Subject: PDM Covers

Models Affected: Specific Freightliner Columbia, Coronado, and Century Class S/T vehicles manufactured between September 7, 2004, and October 17, 2005.

Recall Campaign

December 2006
FL476A
NHTSA #06V-190

Fig. 2, PDM Cover Installation

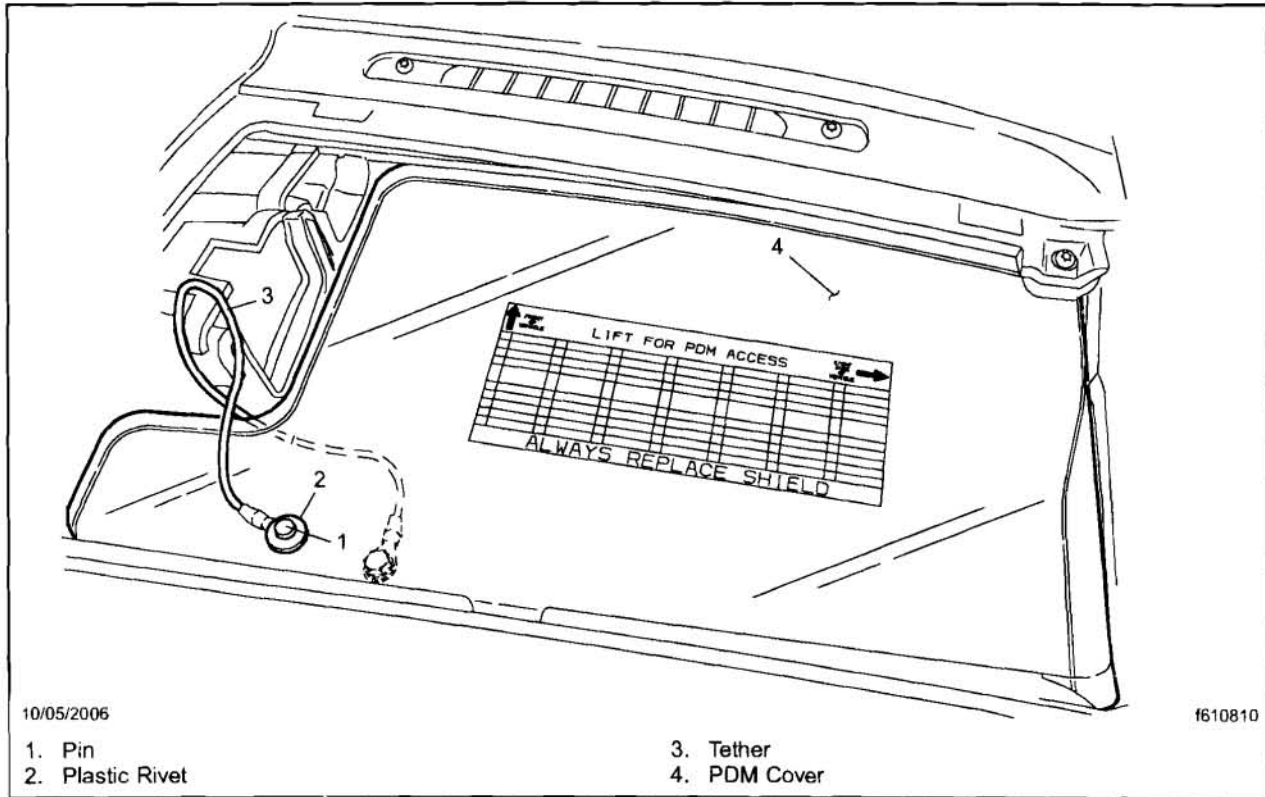
1. Using the previously removed hexnut and washer, attach the tether to the left threaded mounting stud.
2. Position the new cover over the PDM. The cover must be positioned outboard as far as possible to completely cover the battery terminals. The inboard side of the cover should be flush against the HVAC duct, but not under it. See Fig. 2.

Fig. 3, Cross-Section View of Installation

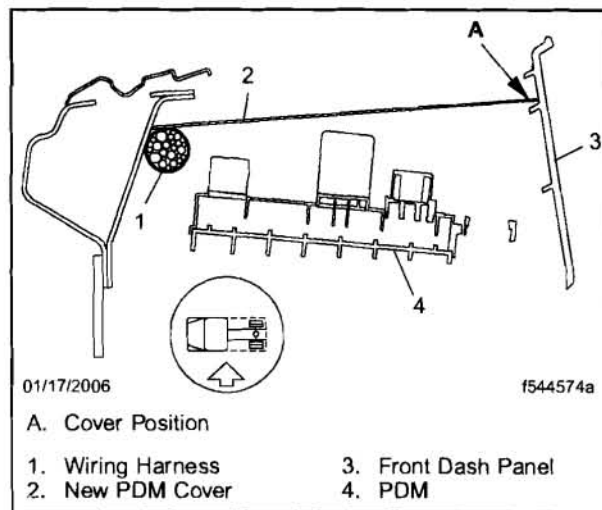
The edge of the cover that is close to the windshield should sit on top of the wiring harness. The edge of the cover that is close to the dash should rest on the second ledge of the inside surface of the front dash panel. See Fig. 3 for a cross-section view of the installation. Ensure that all the PDM wiring is protected underneath the new cover.
